APPLICATION NO.	FILING DATE	FIRST NAMED INVENTOR	ATTORNEY DOCKET NO.	CONFIRMATION NO.
10/578,001	05/03/2006	Shunpei Yamazaki	740756-2967	3719

Office Action Summary	Application No. 10/578,001	Applicant(s) YAMAZAKI ET AL.	
	Examiner MOHAMMAD Timor KARIMY	Art Unit 2894

3. Claims 1-8, 9-10, 16 and 18-19 are rejected under 35 U.S.C. 102(b) as anticipated by Nishio et al. (US Patent 6,046,547) or, in the alternative, under 35 U.S.C. 103(a) as obvious over Nishio et al. in view of Chen (US Patent 6,211,067 B1).

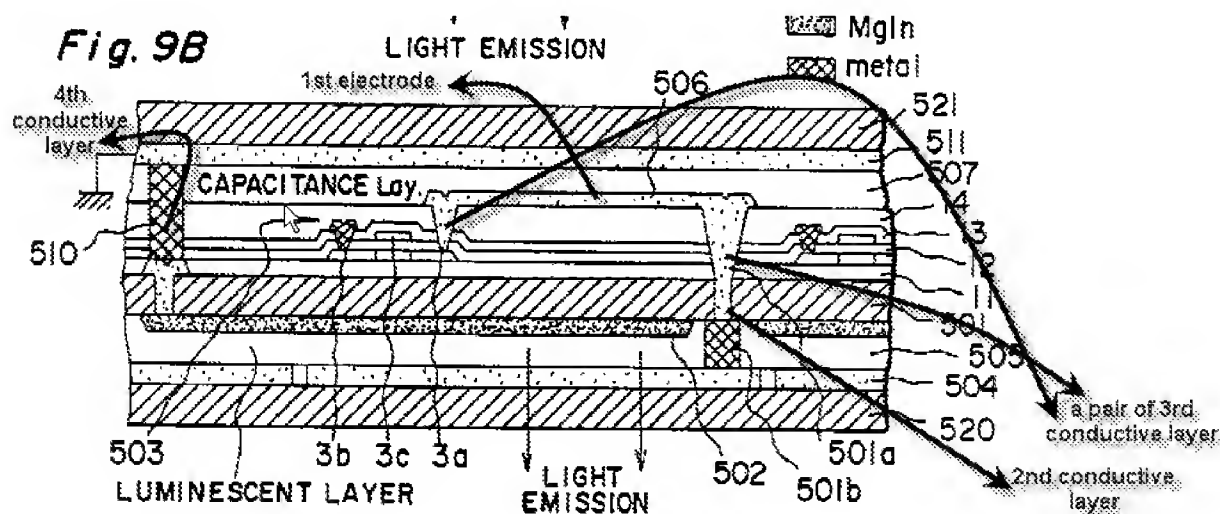
With respect to claim 8, Nishio discloses in figures 1-10, a display device comprising:

wherein the first conductive layer 501a is thicker than the second conductive layer in a vertical direction (see Fig. 9B below), and

wherein the surface of the insulating layer 505 and the first conductive layer is planarized and a uniform surface (see Fig. 9B, wherein the insulating layer 505 and the first conductive layer 501b have a planarized and uniform surface), and

wherein the fourth conductive layer is thicker than the pair of third conductive layer (see Fig. 9B below).

Though Nishio shows planarized and a uniform surface for the conductive layer 501b and the insulating layer 505; however, if it is determined that Nishio does not teach a planarized and uniform surface for the conductive and insulating layers, then Chen patent teaches planarizing the surface of metal plugs and insulating layer by using chemical mechanical polishing (CMP) in order to remove surface roughness and irregularities (Fig. 1A-1E). Nishio and Chen are analogous art (both deal with metal or conductive layers in insulating layers). At the time of the invention, it would have been

It is worth mentioning that the limitation **"wherein each of the second conductive layer and the third conductive layer is formed by a droplet discharge method using a conductive material"** is a product by process limitation and it does not result to a structurally distinguishable product over the prior art.
